VISUAL SITE INSPECTION REPORT – 2018

SOUTHERN INDIANA GAS AND ELECTRIC
A. B. BROWN GENERATING STATION
TYPE III RESTRICTED WASTE LANDFILL
WEST FRANKLIN, IN

ATC PROJECT NO. 170LF00614

January 9, 2019

Drawing Title:
**SITE PLAN
TYPE III RESTRICTED WASTE LANDFILL
A.B. BROWN GENERATING STATION**

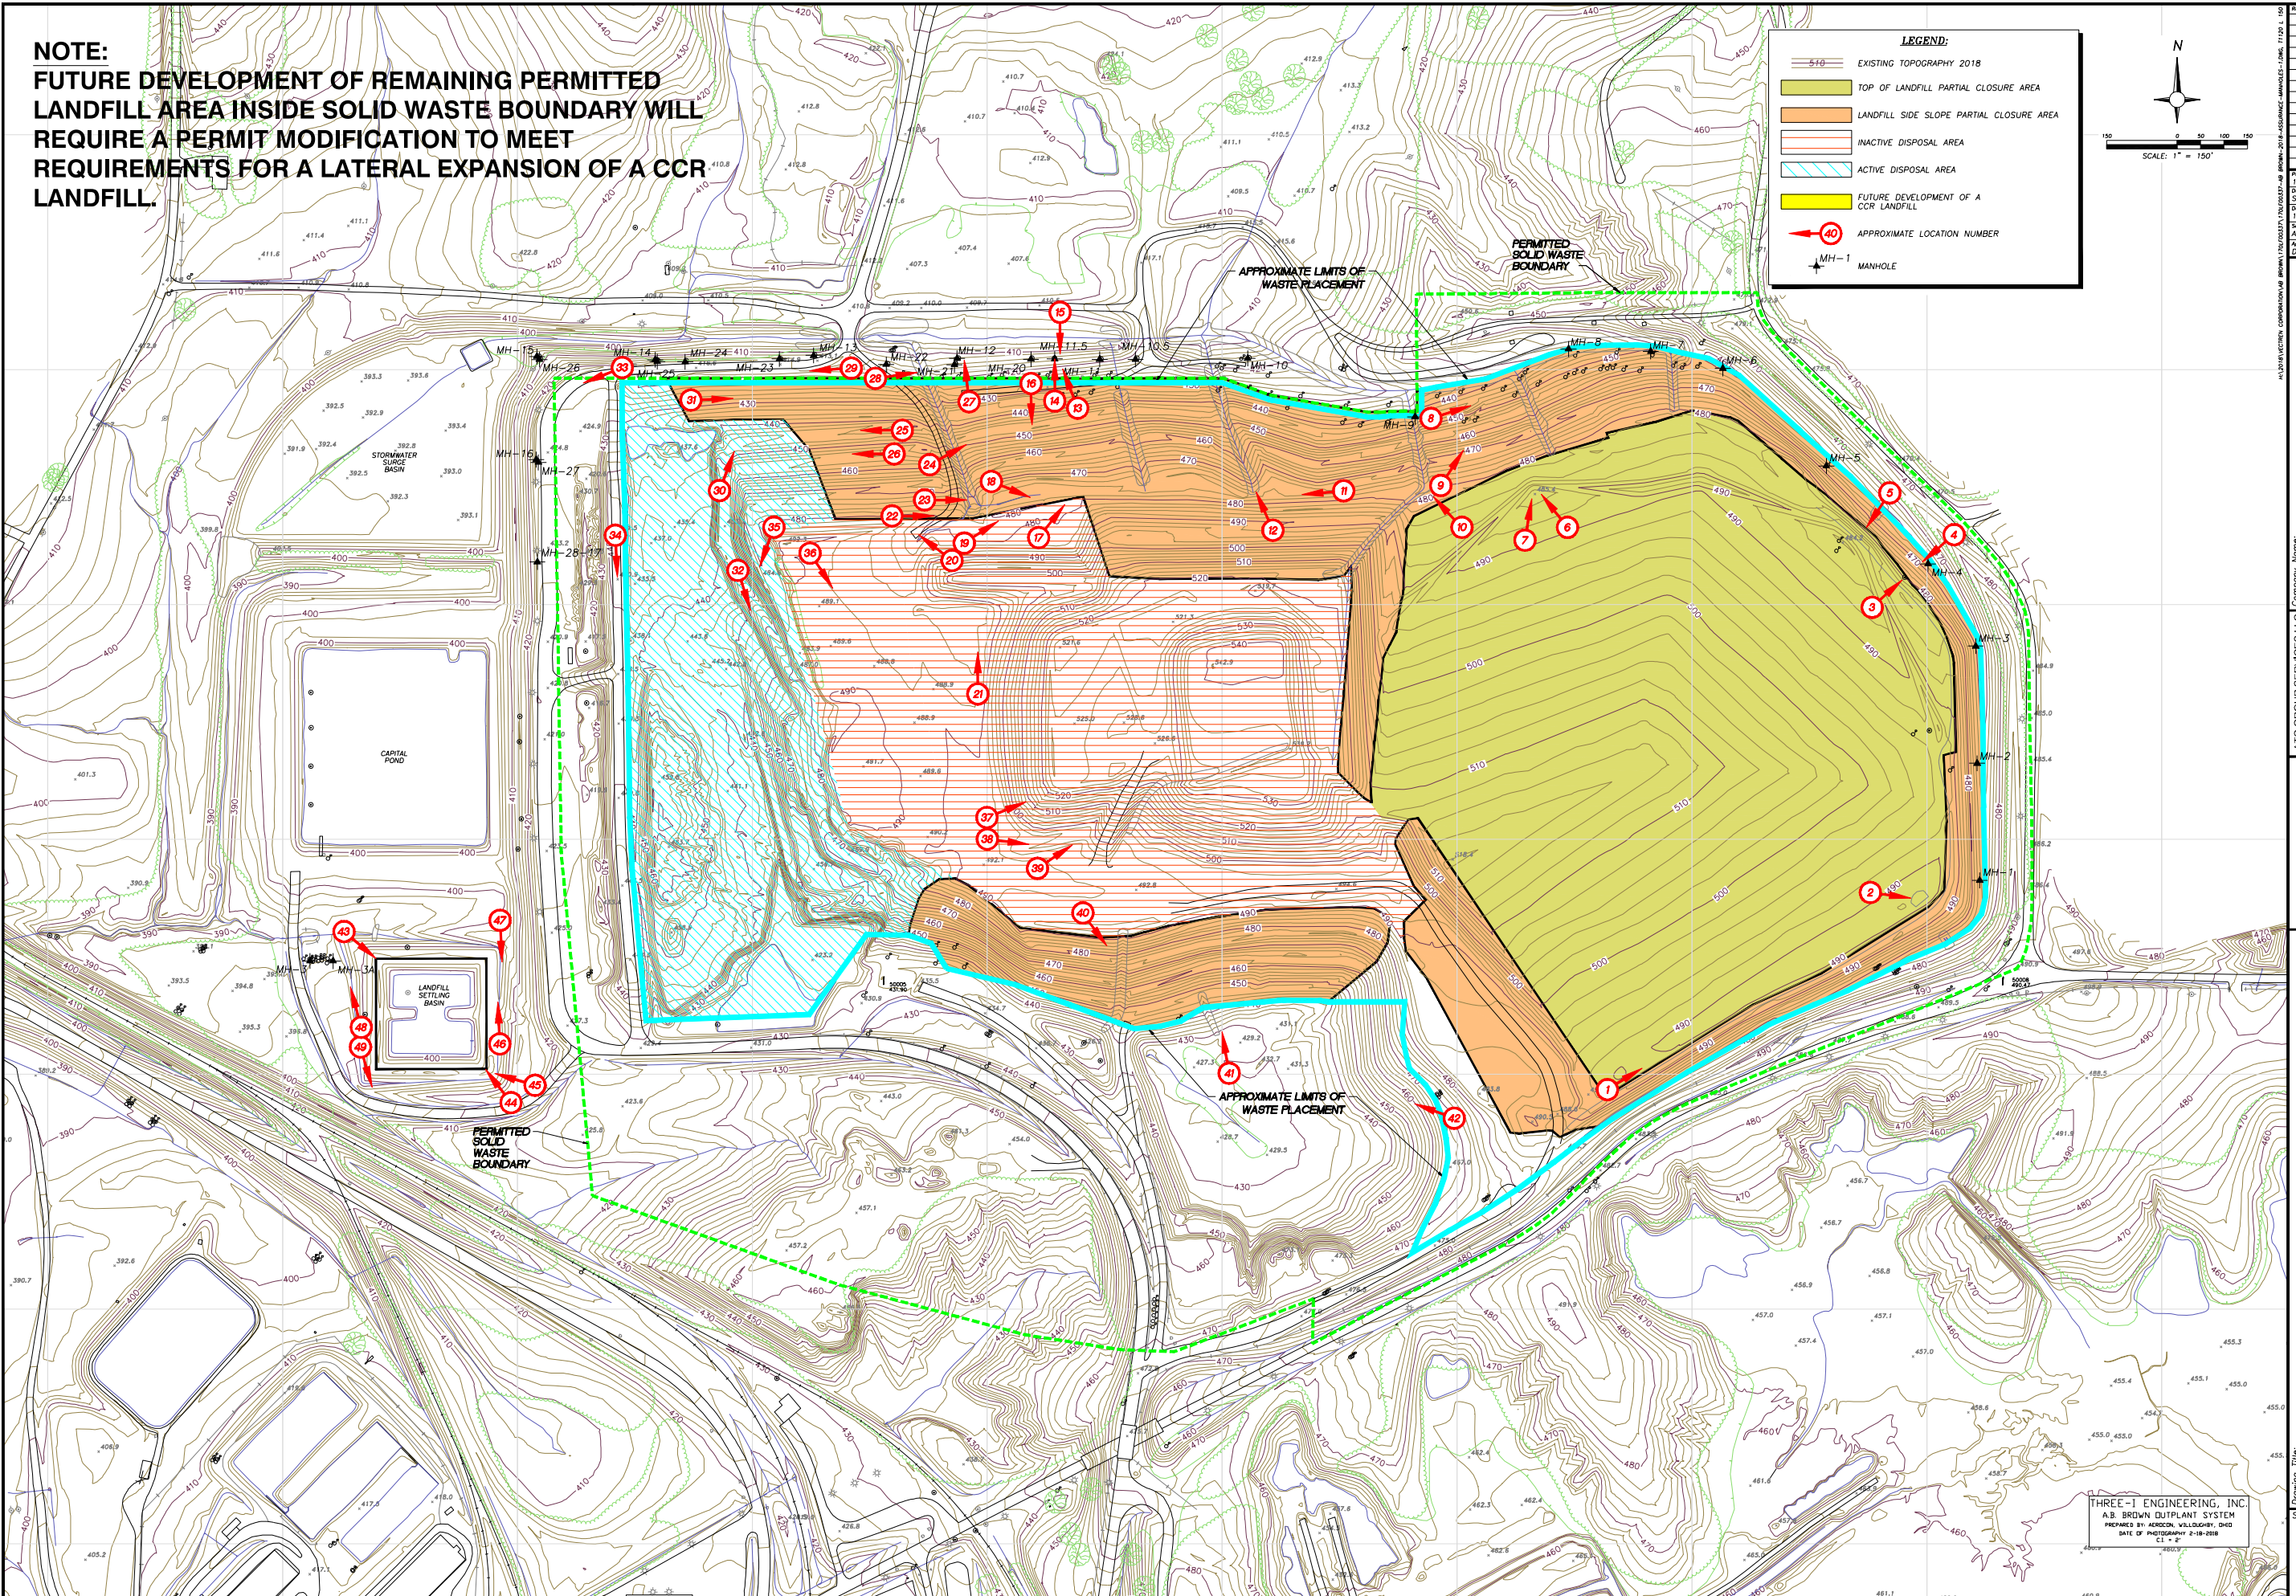
- 2) The inlet to a drainage culvert on the east side of the landfill has been blocked by riprap (Location 3). Additionally, the inspection noted minor erosion at the outlet of the same culvert (Location 4).

- 3) A sinkhole has developed above a culvert outlet on the east slope of the Partial Closure Area indicating a joint failure (Location 5). Additionally, the inspection noted erosion along perimeter of outlet splash pad.

- 4) On the north side of the Top of the Landfill Partial Closure Area, two (2) drop inlets have become clogged with vegetation debris (Locations 6 and 7).

- 5) A seep is present on the north slope near the east end of the landfill. A trench has been excavated in the area to collect the seep water and convey it in pipes to the Capital Pond. It is our understanding that the flow rate varies seasonally and that the peak rate continues to decrease following the construction of the composite final cover across the top of the east end of the landfill (Location 8).

- 6) On the north slope of the Landfill Partial Closure Area, several of the riprap channels have become overgrown with vegetation along edges of the stone reducing the flow into the channels (Location 10).

- 7) On the north slope of the Landfill Partial Closure Area, flow from the outlet of a down-drain culvert is causing erosion and undercutting at the opening of a riprap channel (Location 12).

- 8) On the north slope of the Landfill Partial Closure Area, an HDPE pipe has been installed from the active fill operations in the Vertical Expansion Area to Manhole #11.5 (Locations 13, 15, 16, 21, and 28). At the time of the inspection, there were no erosion or sediment controls installed upstream of the pipe inlet (Locations 17 and 18) allowing filter cake sediment to flow directly into the pipe and into the stormwater management system outside of the Solid Waste Boundary. As a result, Manhole #11.5 accumulated a significant volume of sediment (Location 14). Based on the presence of filter cake sediment on the outside of Manhole 11.5 and erosion at the base of Manhole 11.5, it also appears that the manhole recently overtopped allowing filter cake to discharge to the perimeter ditch (Location 13). At the time of this inspection, there was no evidence to indicate migration of waste beyond the property boundary.

- 9) A sediment control pond surrounded by silt fence was constructed to the west of the inlet to the HDPE pipe discussed in Item 8 (Location 18). It appears that the sediment pond was recently overtopped leaving the fence in poor condition and allowing filter cake to flow west as indicated by filter cake in the grass (Location 19). The filter cake flowed west until it reached a culvert under a roadway that was partially clogged with vegetation (Location 20). The culvert flows under the roadway and outlets on the north slope of the Landfill Partial Closure Area (Location 22) causing erosion of the roadside drainage channel. The filter cake also appears to have migrated to the culvert outlet/riprap channel at Location 23. The flow through the culvert to the north slope of the Landfill Partial Closure Area creates another path for filter cake to migrate outside the Solid Waste Boundary. At the time of this inspection, there was no evidence to indicate migration of waste beyond the property boundary.

- 10) The inspection noted water ponded in the toe of a diversion berm on the north slope of the Landfill Partial Closure Area (Location 24).

- 11) The inspection noted erosion in the toe of several diversion berms on the north slope of the Landfill Partial Closure Area (Locations 25 and 26).

- 12) The inspection noted seepage around Manhole #12 (Locations 27). Previous inspections have determined that seepage from a manhole may indicate a blockage in the drainage system.

- 13) The inspection noted recent reseeding in the perimeter ditch north of Manhole #12 (Location 28). The inspection also noted filter cake in a drainage ditch adjacent to a road outside of the Solid Waste Boundary (Location 29). Further discussions with site personnel indicated that recent heavy rains had caused sediment transport of the filter cake into the stormwater management system requiring clean up to remove filter cake, and reseeding of the perimeter ditches. At the time of this inspection, there was no evidence to indicate migration of waste beyond the property boundary.

- 14) The top of a slope of the north side of the Active Landfill Area has been graded to flow onto a diversion berm on the north side of the Landfill Partial Closure Area (Location 30) creating another path for filter cake to migrate outside the Solid Waste Boundary.

- 1) The inspection noted a steep cut-slope with a road at the top of the slope on the south end of the east side of the Active Landfill Area (Location 32).

- 2) At the northwest corner of Cell 18 at the edge of the haul road, the standing water surface in the cell is only slightly below road elevation indicating a small amount of freeboard (Location 33). During large magnitude storm events the cell may become more susceptible to overtopping.

- 2) Water is ponding at the toe of the filter cake slopes (Locations 21 and 38). It appears that water ponded at the toe of the south slope of the Vertical Expansion Area is pumped into a box culvert (Location 39) that discharges into a riprap channel (Location 40) that flows into a sediment pond at the toe of the slope within the Solid Waste Boundary.

- 2) The southeast portion of the pond has accumulated a large volume of sediment that may impair the discharge into the pond (Location 44).

- 4) The inspection noted erosion in the perimeter drainage channels near the northeast corner of the pond (Location 47) and along the west side of the pond (Location 48).

- 5) The inspection noted that the area around the southeast corner of the pond is not graded to drain and is ponding water (Location 49).

Recommendation: Remove riprap as needed to allow water to flow into the culvert on the upstream side of the culvert and add riprap to the downstream side to control erosion.

Recommendation: Excavate the culvert to expose the failed joint. If the joint connection appears to be intact, reset the joint and add an Agri Drain Pipe Strap, or an equivalent. If the joint or the pipe segment has been damaged beyond repair, replace the pipe segment and add an Agri Drain Pipe Strap, or an equivalent, to reinforce the joint. Also, remove the eroded soil from the perimeter of the splash pad and add additional riprap to prevent future erosion.

Recommendation: Remove grass clippings and vegetation debris to restore the original condition.

Recommendation: Continue to collect and convey the seep water to the Capital Pond.

Recommendation: Trim vegetation at the edges of channels at regular intervals to maintain open flow conditions.

Recommendation: Add riprap to the outlet of the culvert to reduce the flow velocity and monitor the opening of the channel for further erosion.

Recommendation: Add sufficient erosion and sediment controls upstream of the pipe inlet to prevent filter cake from migrating outside the Solid Waste Boundary. Alternatively, reroute stormwater flows to the west into the Active Landfill Area.

Recommendation: Repair and maintain the silt fence in good condition, increase and maintain freeboard in the sediment control pond to prevent overtopping, and install additional erosion and sediment controls downstream of the pond to prevent filter cake from migrating outside the Solid Waste Boundary. Alternatively, reroute stormwater flows into the Active Landfill Area. Additionally, trim the vegetation at the culvert inlet at regular intervals to maintain open flow conditions.

Recommendation: Add soil to the diversion berm and revegetate the area as necessary to maintain flow into the drainage structures.

Recommendation: Restore the diversion berms as necessary and improve the armoring at the flow lines to prevent erosion.

Recommendation: Continue a regular maintenance program of the toe drain lines to minimize the potential for development of blockages.

Recommendation: Remove filter cake from drainage features and improve erosion and sediment controls within active placement areas in the Vertical Expansion Area to prevent migration of filter cake outside of the Solid Waste Boundary and continue proactive maintenance of stormwater controls.

Recommendation: Add sufficient erosion and sediment controls inlet to the diversion berm to prevent filter cake from migrating outside the Solid Waste Boundary. Alternatively, reroute stormwater flows to the west into the Active Landfill Area.

Recommendation: Immediately prohibit use of the road at the top of slope and regrade the area to re-establish safe slopes within the Active Landfill Area. Consider adding traffic control berms to the outside edge of roads at the top of a slope.

Recommendation: Maintain a low normal pool elevation inside the cell collection area and continue to monitor elevation rise during storm events. Consider additional drainage from inside the cell or the addition of a soil berm to increase freeboard in this area.

Recommendation: Continue to minimize ponded water within the active fill areas.

Recommendation: Remove accumulated sediments to maintain the pond capacity. The owner has reported that this action was completed following the site inspection.

Recommendation: Restore the perimeter drainage channels as necessary and improve the armoring at the flow lines to prevent erosion.

Recommendation: Regrade the area as necessary to maintain drainage.
